# Keysborough South Community Hub - Proposed New Playground (Final Concept) Consultation Summary Report

APRIL 2021

**PREPARED BY**  
Planning and Design Team

## PROPOSED PLAN

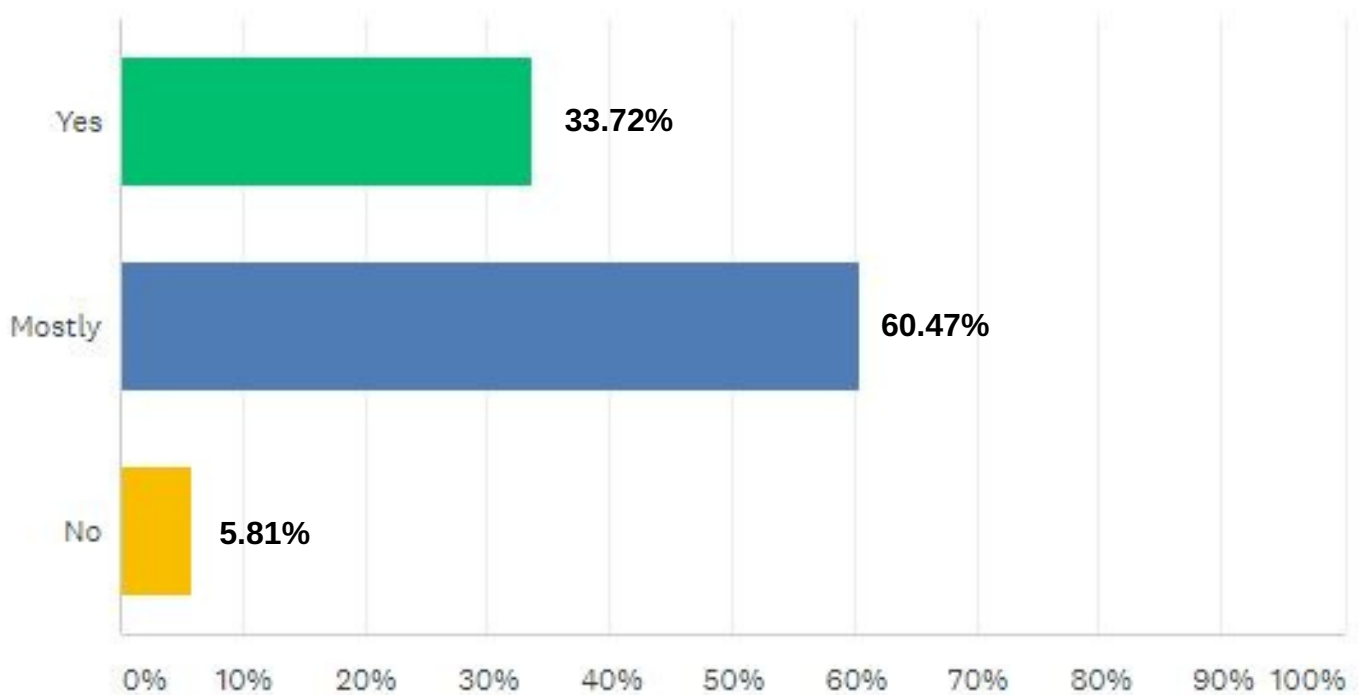
Would like to see more shade for the kids, trees are fine but won't be fully grown for some time and also not always close enough to play areas to make a difference. Consider some shade sails such as the Ants Playground nearby.

Water play is missing in most of our playgrounds. A tiny section is in Tatterson Park. I'd be more inclined to make this more geared toward young children (0-5) as most playgrounds don't accommodate the smallest community members.

Looks boring and needs more play equipment and more sports facilities instead there is already half-court basketball down the road at Ian Tatterson. How about tennis court or wall? Kids love climbing hills how about a big hill with a slide?

Would like an all sports area for the older kids - not just basketball

Needs one more bbq and normal swings set.

-  A water play area would be a fantastic addition to the park. Shade BBQ areas would also be great.
-  Please think of all age groups of children.
-  Are the toilets in the community hub going to be accessible at all times? If not, then then toilet/family change room facilities need to be built for park user access.

-  I love the design and the ideas for inclusive all around age types. I'd like to see a few more tables and chairs for seating. Why? I'd like to think we can also use the external areas for community group to gather.....It seems the seating is limited in the area.

A small component of water sensory play that is suited to the size and scale of this neighbourhood level playground will be included in the revised design for this playground.

The inclusion of sand play as part of the water sensory play component will also be incorporated into the revised design.

However, a fusion soccer / basketball goal will be added to the revised design for the half court.

**Council Response:** The revised design will include opportunities for the provision of additional shade with tree planting and shelters.

The design of the bbq and picnic area will be reviewed to include additional bbqs, picnic tables and seating.

A swing set will be included in the revised design of the playground.

**Council Response:** The playground layout will be reviewed to see whether the inclusion of a small trampoline can be included in the updated design.
